Access Compliance Report

Public Rights-of-Way

(Curb Ramps)

Intersection ID: 25333	Main Street: CARMEL_RD	Cross Street: MEADOWRIDGE_DR	Location: W
ADA ID: 0AC05F167488	Ramp Type: PerpDiag	Initial Pass/Fail: Fail	Overall Compliance: No
Severity Score: 46.25			
Codes/Mitigation Info/Possible Solution		Field Measurements/Component Compliance

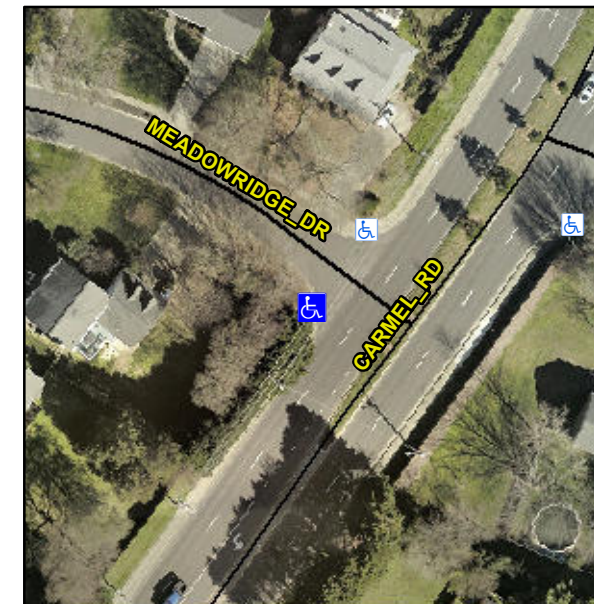
Not Found, R304.5.1, R304.2.2, R304.5.3

Compliance	Description	Data	Compliance	Description	Data
N/A	Ramp Length (in)	60.0	No	Ramp Slope (%)	14.1
No	Ramp Width (in)	37.0	No	Ramp XSlope (%)	5.8
N/A	Flare Type LT	N/A	N/A	Flare Type RT	N/A
N/A	Flare Slope LT (%)	N/A	N/A	Flare Slope RT (%)	N/A
N/A	Flare Traversable LT?	N/A	N/A	Flare Traversable RT?	N/A
N/A	Landing Length (in)	N/A	N/A	DWS Provided?	N/A
N/A	Landing Width (in)	N/A	N/A	DWS Contrast?	N/A
N/A	Landing Slope (%)	N/A	N/A	DWS Length (in)	N/A
N/A	Landing X Slope (%)	N/A	N/A	DWS Full Width?	N/A
N/A	Landing Curb? (Y/N)	N/A	N/A	DWS Offset (in)	N/A
N/A	Shared Landing?	N/A			
N/A	Gutter Ponding?	N/A	N/A	Gutter Slope (%)	N/A
N/A	Gutter Lip Ht (in)	N/A	N/A	Gutter X Slope (%)	N/A
N/A	Painted X Walk1?	No	N/A	Painted X Walk2?	No
	X Walk 1 Direction	To SE		X Walk 2 Direction	To NE
N/A	X Walk 1 Width (in)	N/A	N/A	X Walk 2 Width (in)	N/A
	X Walk 1 Slope (%)	1.0		X Walk 2 Slope (%)	1.6
	X Walk 1 X Slope (%)	0.7		X Walk 2 X Slope (%)	3.5

Remove & Replace Curb Ramp With Two New Directional Ramps or Equivalent.
